# DEVELOPMENT REVIEW BOARD REPORT

MEETING DATE: December 6, 2007

**48-DR-2007  
Monument Club**

*Approval of a site plan, landscape plan and building elevations for new resort timeshare units and associated amenities.*

A-9

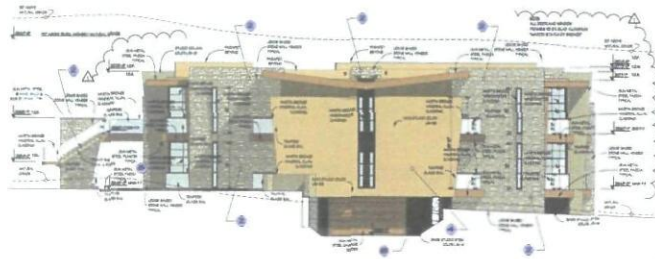
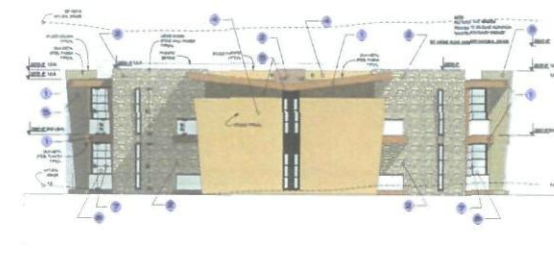
2. *The owner shall install the automatic sun screens as shown on sheet A-9 in detail 5 wall section A on all windows that do not access a patio.*
3. The face of the service entrance section(s) shall be flush with the building façade and painted to match the building.
